UNITED STATES PATENT AND TRADEMARK OFFICE

APPLICATION NO.	FILING DATE	FIRST NAMED INVENTOR	ATTORNEY DOCKET NO.	CONFIRMATION NO.
10/679,421	10/07/2003	Michio Masuda	TOC-0008	3476

Office Action Summary

DETAILED ACTION

KOBUSCH Fig 5

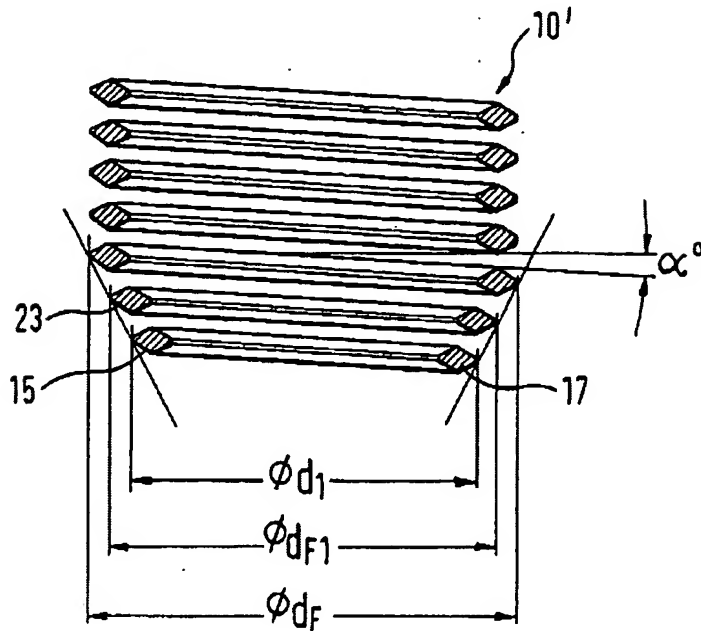
Kobusch teaches a spiral coil shaped insertion body formed by coiling a rhombic cross-section wire (Fig 2 or 5) and capable of insertion into a female screw and capable of receiving a male screw, the spiral body comprising:

- a cylinder portion of fixed diameter (straight portion formed by top 5 threads above)
- a tapered portion with outside diameter reduced from cylinder portion toward distal end of spiral body (tapered portion formed by bottom 3 threads above)
- the outside thread pitch diameter of cylinder section $>$ pitch diameter of the female screw (col 3 lines 1-12, col 4 lines 7-19)
- the inside thread pitch diameter of a region of the taper portion covering 1 or more turns $<$ pitch diameter of a male screw. There is a male screw that is usable with the coil which has a pitch diameter larger than the inside thread pitch diameter of the taper portion. No male screw limitation is positively recited.
